**ADDENDUM NO. 2**

**ISSUE DATE:** 2/18/2026  
**FSCJ ITB NUMBER:** 2026C-24  
**FSCJ ITB TITLE:** Wayfinding Monument Entrances at Various locations at South Campus

# Florida State College at Jacksonville ITB 2026C-24

## Titled: Wayfinding Monument Entrances at Various locations at South Campus

**S1.03**

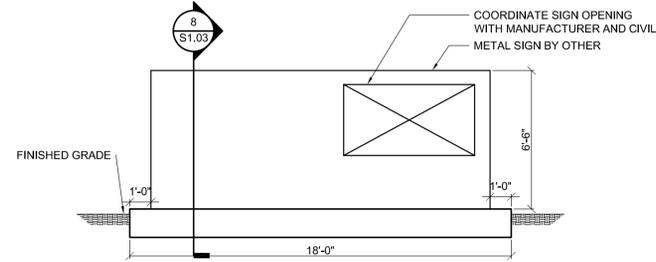
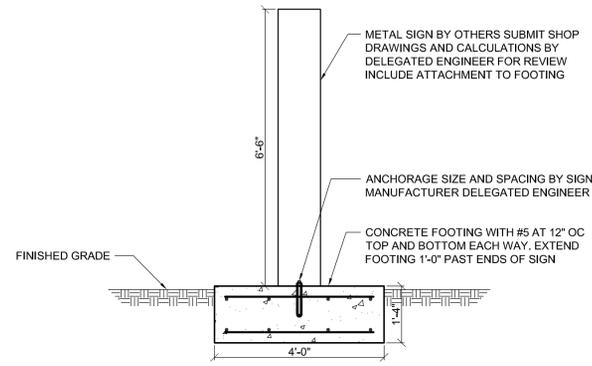
- A:** **No plants are being installed at the entrance at Alden Road. The reference to 2/IR 1.02 has been removed from sheet IR0.01.**
13. **Q:** Detail 1/LS2.04 references footings to be designed by structural. Structural drawings do not include drawings for these sign types. Please clarify.

- A:** **See updated Structural Drawings**
